Town of Kittery Planning Board Meeting February 14, 2019

ITEM 2 - 459 U.S. Route One – Site and Subdivision Final Plan Review

**RE: Town of Kittery, Planning Board Services
Final Site Plan Review Application
The Homestead 459 U.S. Route 1 (Tax Map 60, Lot 24)
CMA #591.121**

SCALE: 1" = 80'
DATE: 02/08/2018
JOB NO: C052-18 FILE: THE HOMESTEAD BASE SHEET 6.2

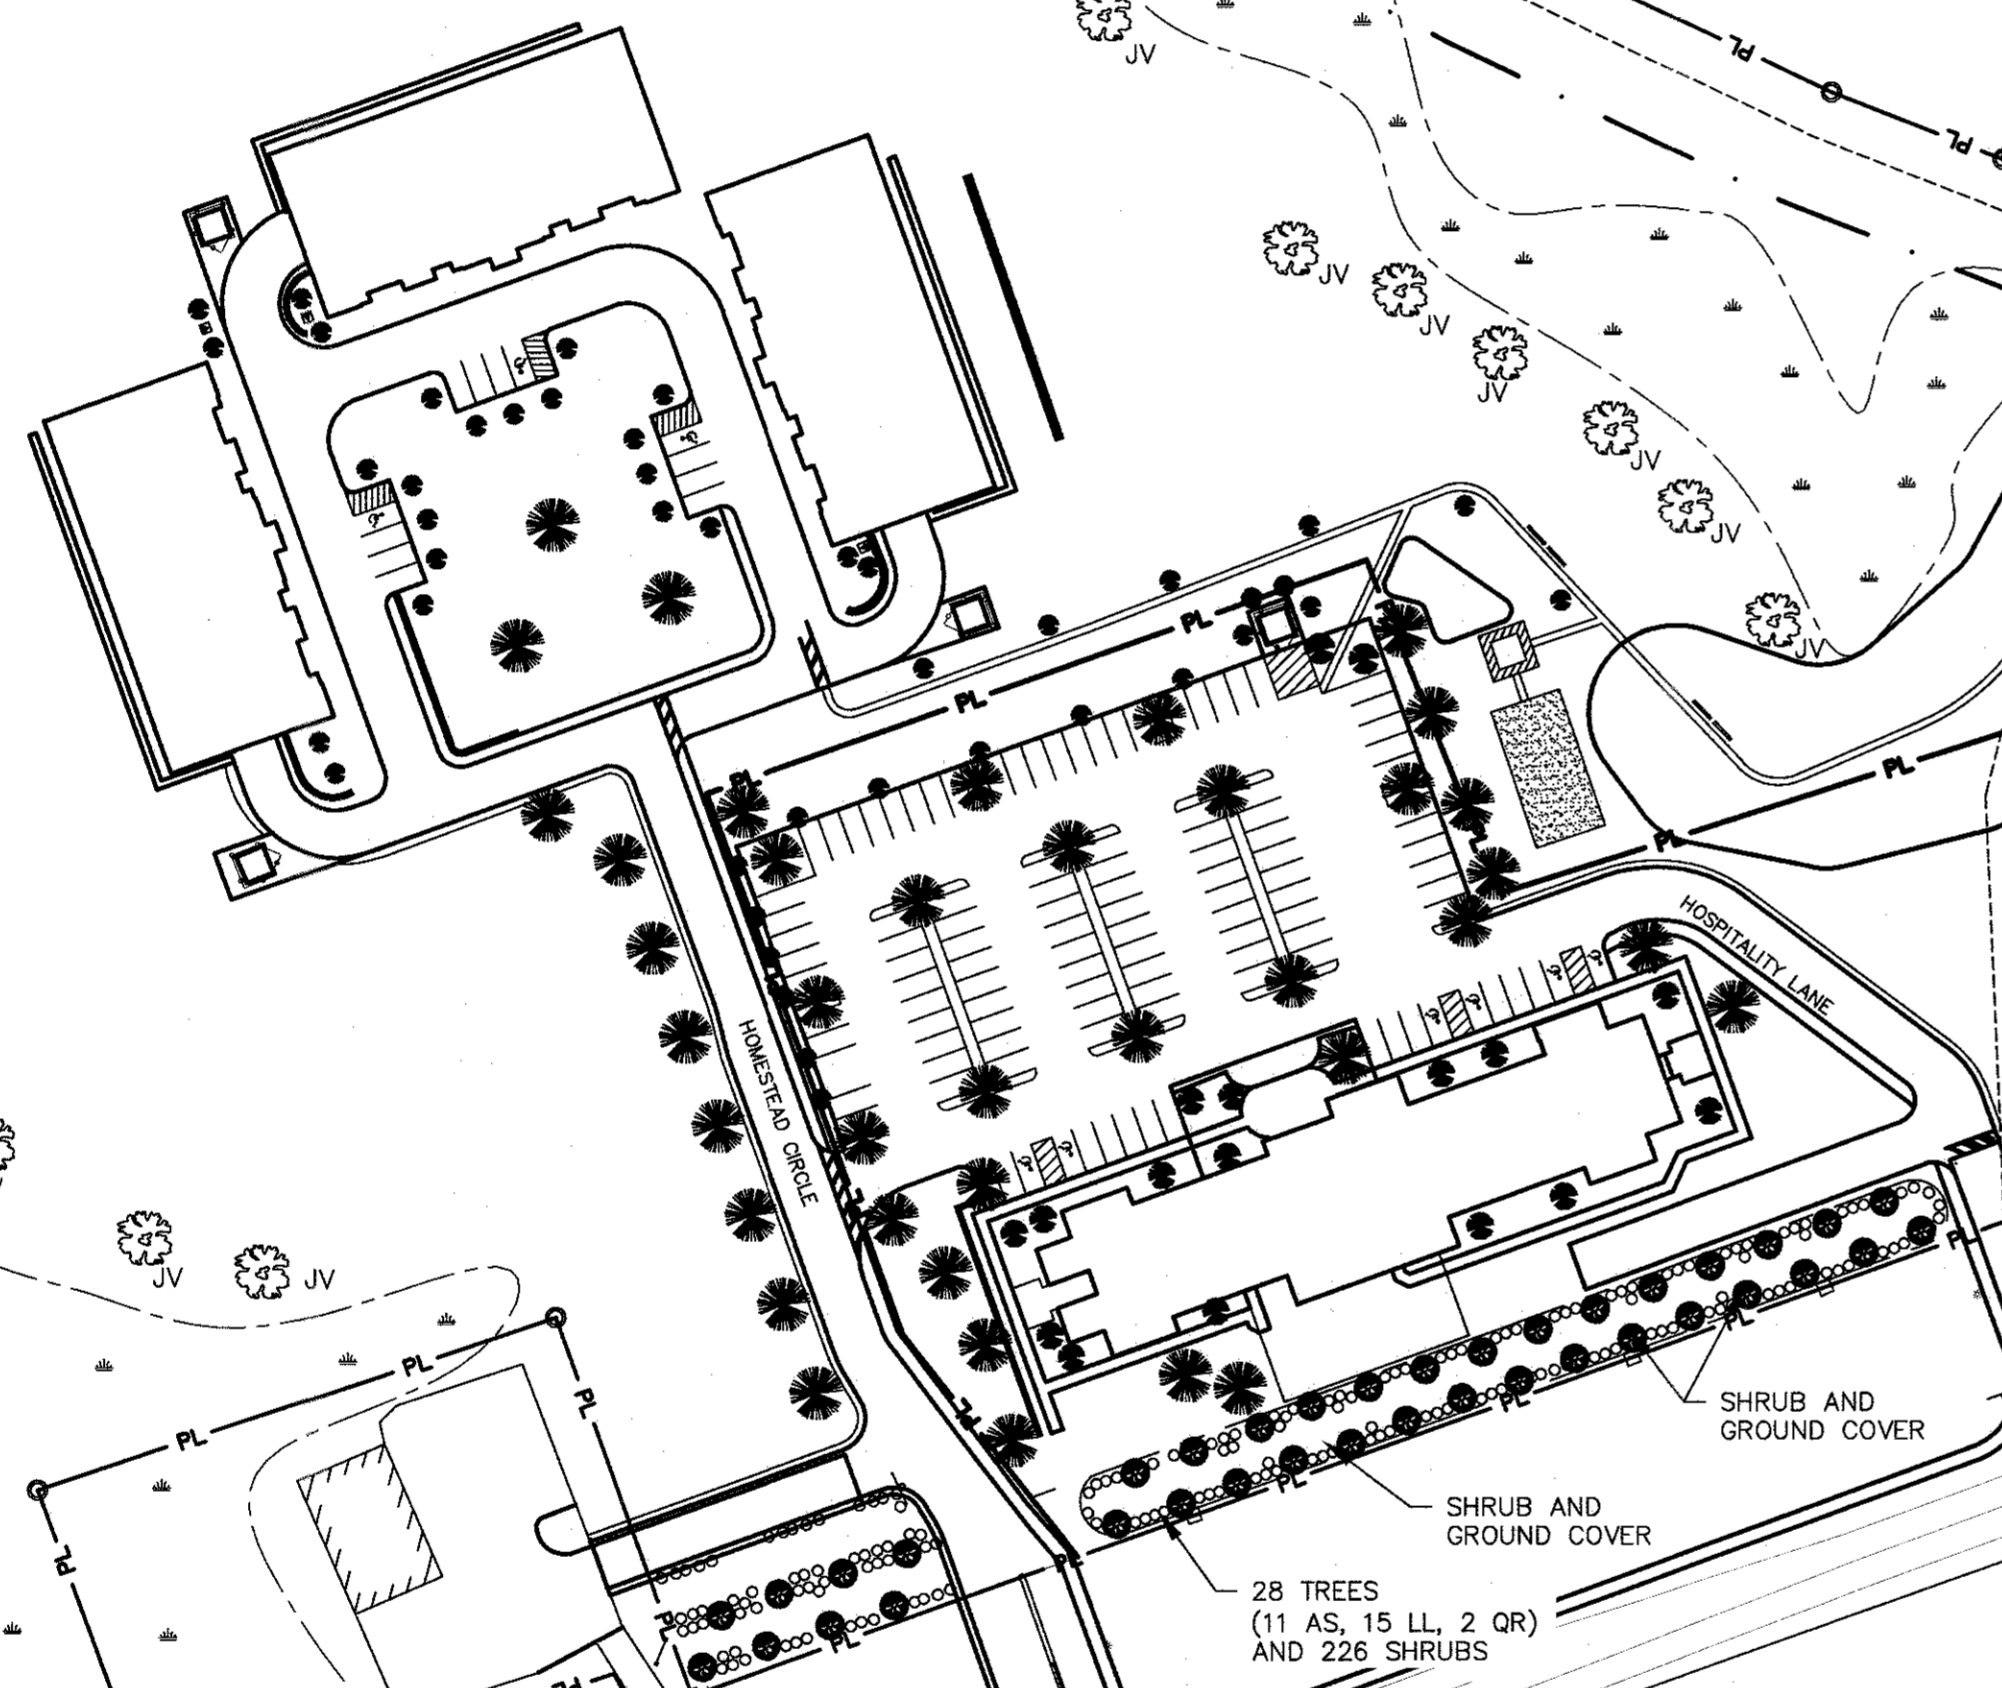
Update: A detailed landscaping plan has been submitted as Sheet 6.2. It appears to meet the required standards for the Mixed Use Zone and the landscaping standards contained in Chapters 16.8 and 16.9. It is not clear, however, from the plan sheet what evergreen types are due to the lack of symbols and a species listing.
